# Access Compliance Report

## Public Rights-of-Way

### (Pedestrian Signals)

Intersection ID: N/A	Main Street:	Cross Street: N/A	Location: N/A
ADA ID: 58432D918292	Signal Type: One Push Button-Non APS	Overall Compliance: No	Severity Score: BTN 1: N/A BTN 2: N/A No BTN: N/A
Codes/Mitigation Info/Possible Solution		Field Measurements/Component Compliance

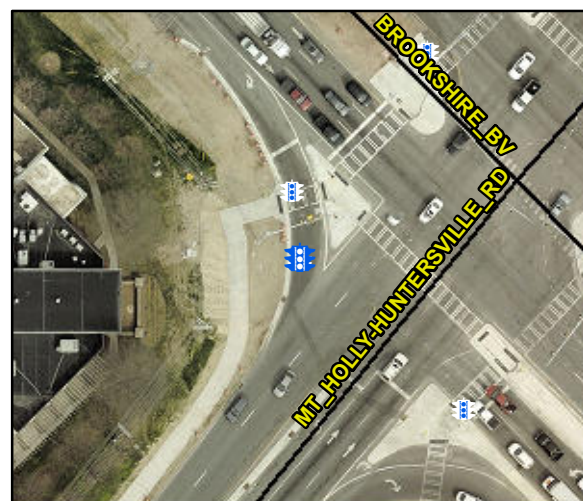
Possible Solutions: Replace Signal Push Button With APS Button on New Post. Remove & Relocate Sign.

PROW/ADA: TMUTCD 4e.08, R404.7.3, R404.7.2
